Horizon Package Review: X2A

dwc_ap_lpddr4x_mphy_tsmc16ffc18: LPDDR4/4x,DDR4 at 4266MT/s

Synopsys SIPI Team

31/03/2020

Signal spacing

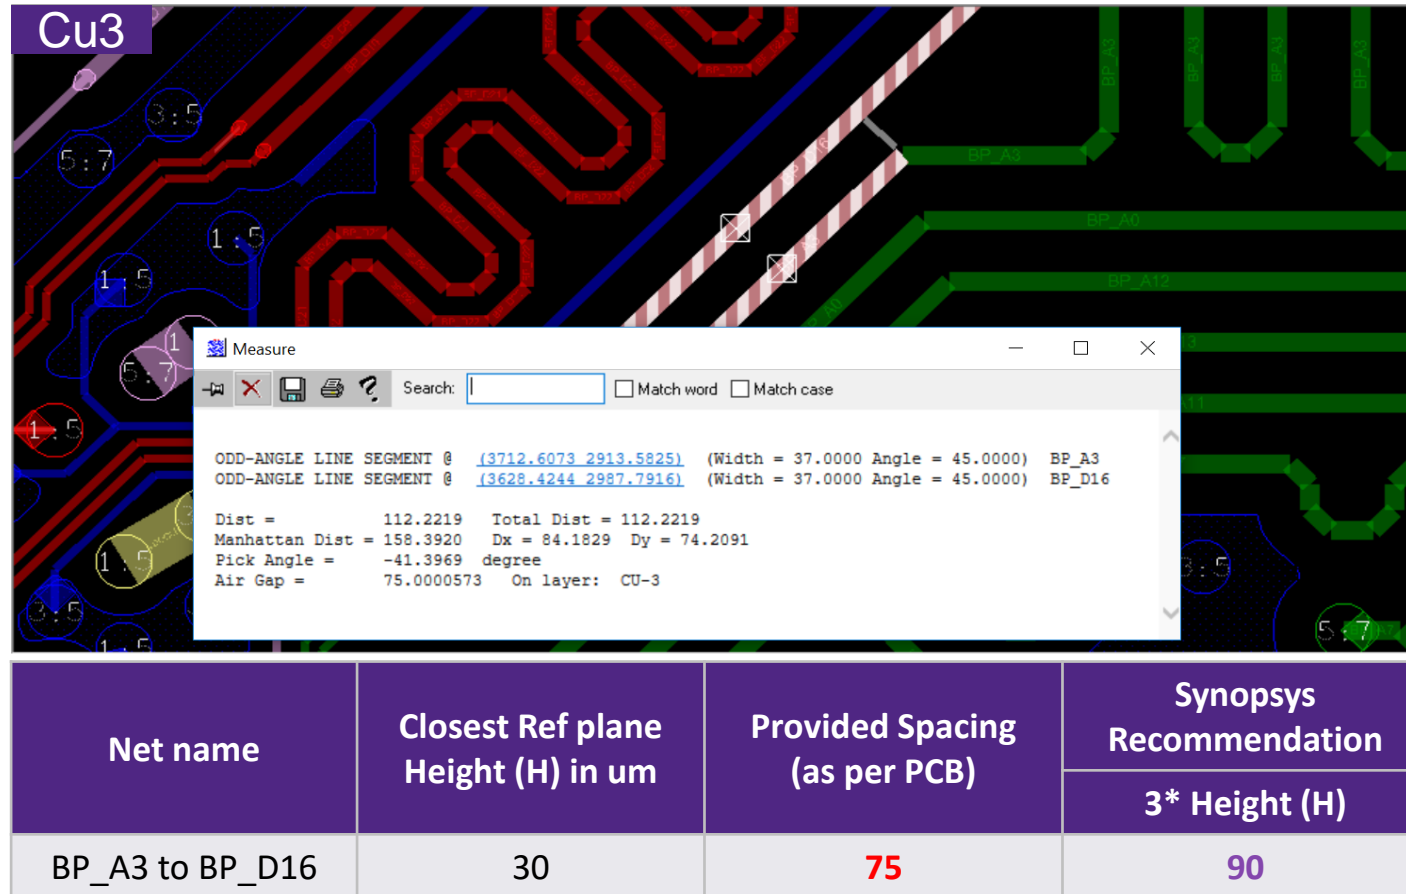
- $\geq 3H$ spacing should be followed between the signals of different group. (H-Height from the reference plane)
- The impact of spacing must be assessed by running crosstalk simulations

Spacing is not as per the recommendation

Propagation Delay Difference (Calculated)

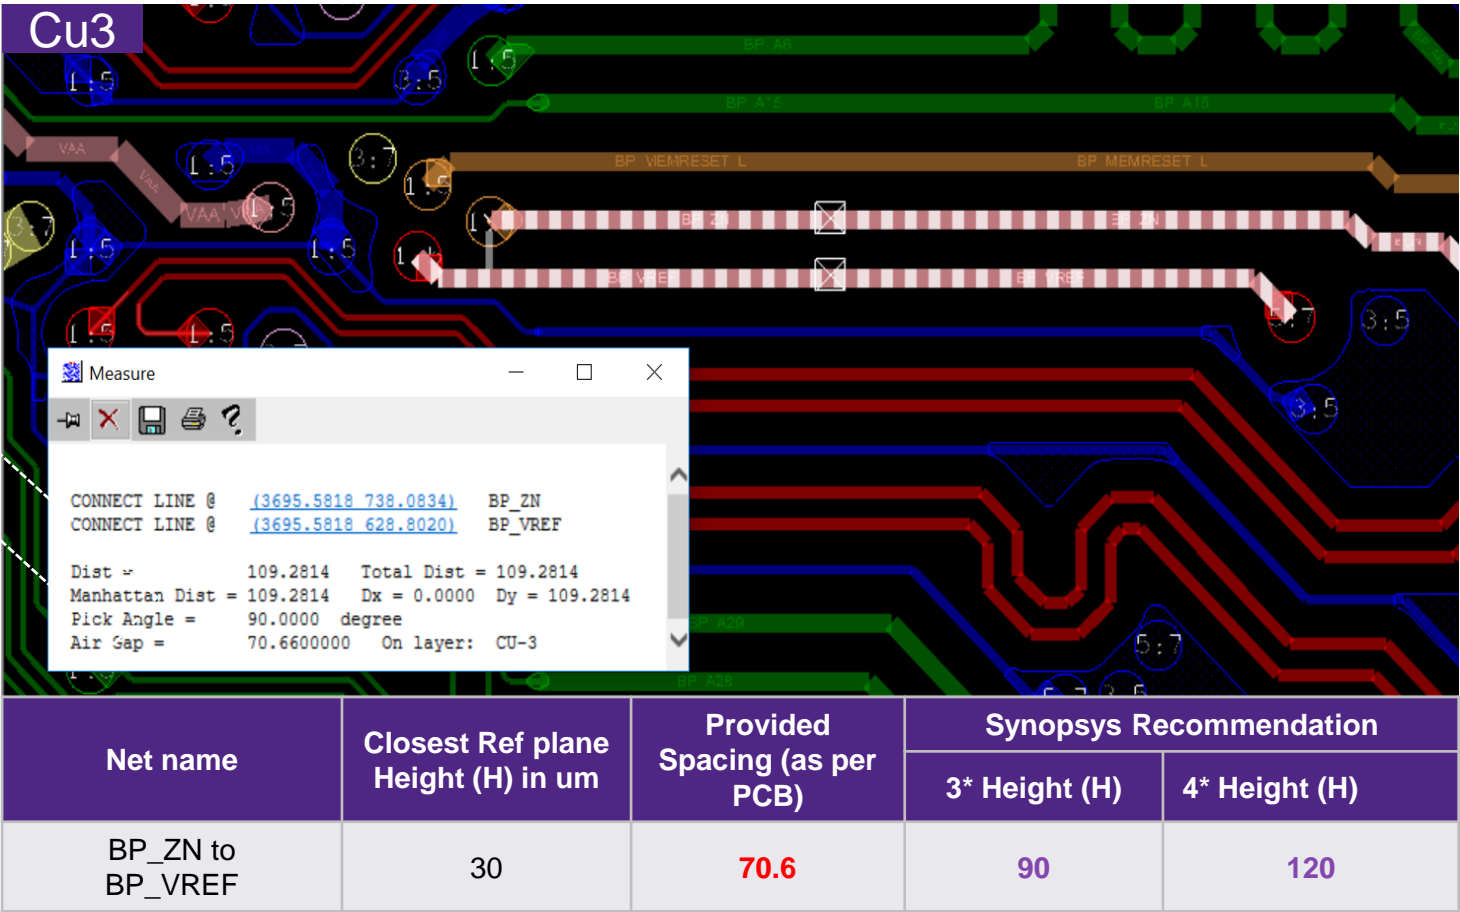
- The provided trace length data is not clear about the byte lane groups (DQ/DQS), differential clock & CAA Signals to calculate the propagation delay difference.
- The total skew must be calculated taking into account the RDL, Package & PCB skews.

Simulation results and calculation of timing budget tables considering all the contributions **[RDL + Package + PCB]** will allow us to understand the impact on the margins and on the performance of the interface.

PLL spacing

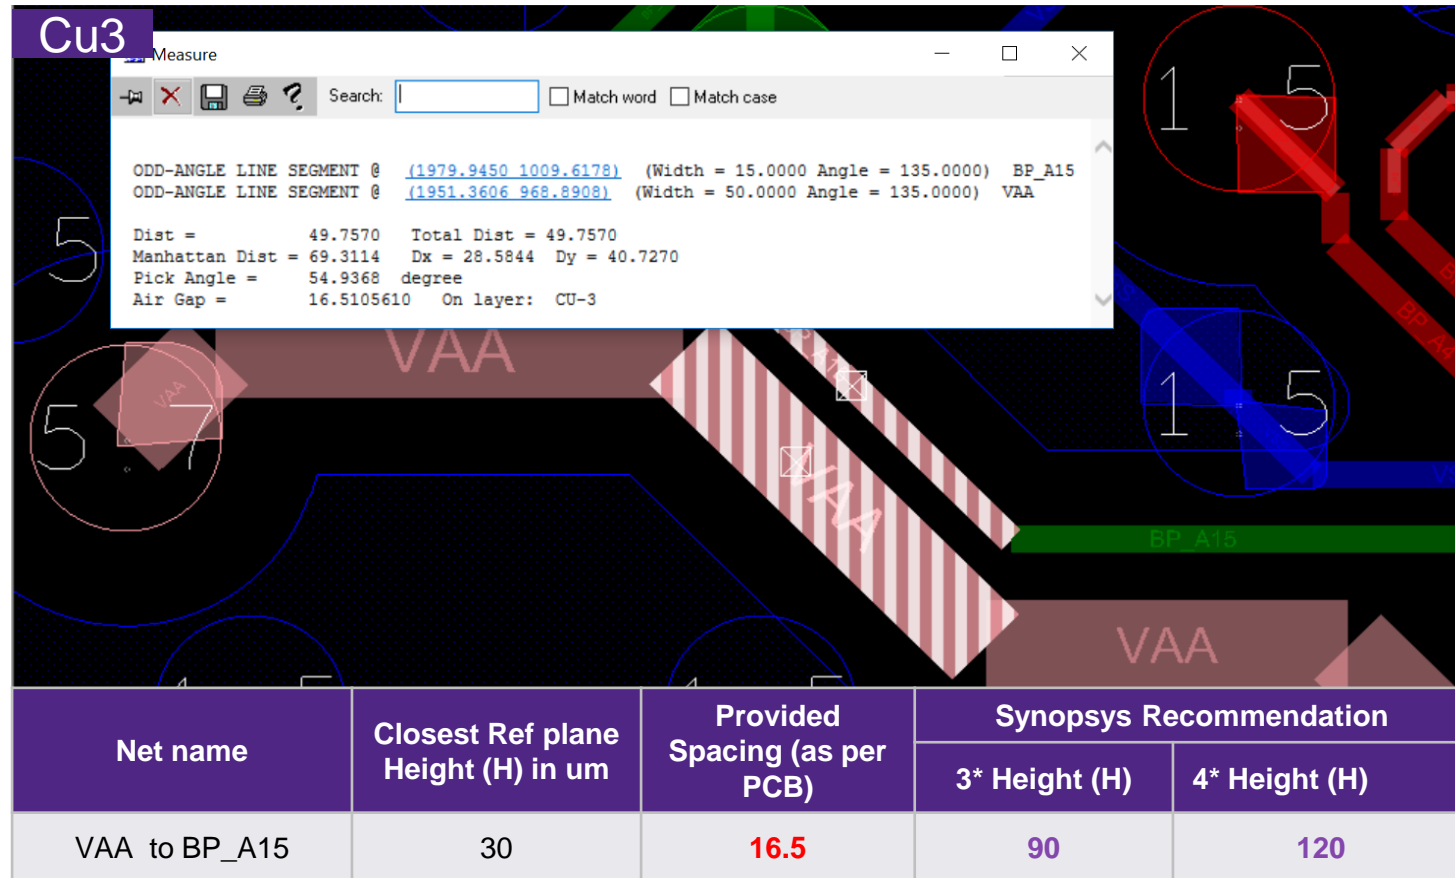
- Requirement is $\geq 3H$ to adjacent traces. H is the distance to the nearest reference plane.

Spacing is not as per the recommendation

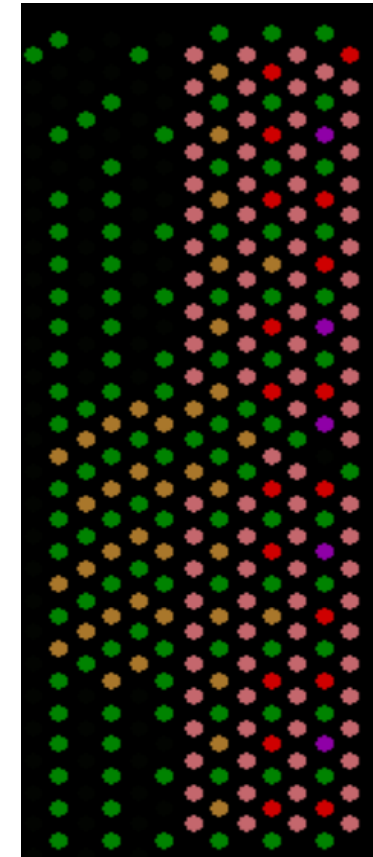
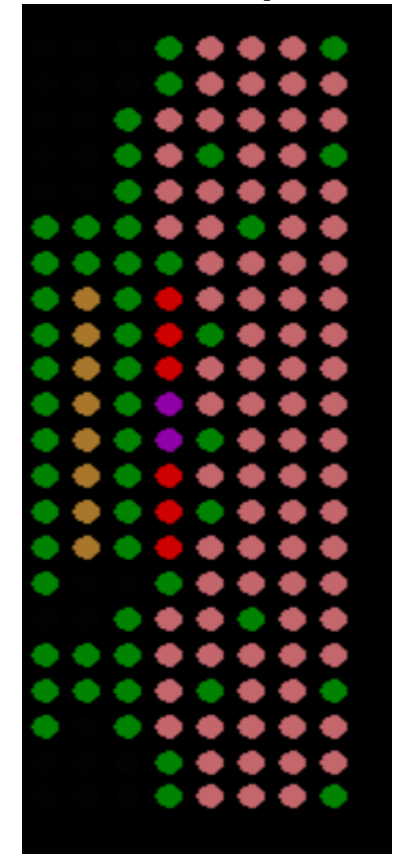
6 VDDQ BGAs. That calculates to $68/8 = 8.5$ signals per VDDQ_DDR BGA.

2 VDDQLP BGAs which calculates to $68/2 = 34$ signals per VDDQLP BGA

By comparison the 200ball lpddr4x DRAM used on the board has..

24 VDD2 BGAs (VDDQ). This calculates to $68/24 = 2.8$ signals per VDDQ BGA

20 VDDQ BGAs (VDDQLP). This calculates to $68/20 = 3.4$ signals per VDDQLP BGA.

Recommended to approach these ratios for VDDQ (3:1:1). There is more margin for VDDQLP since the ripple spec is higher (+/-5%)
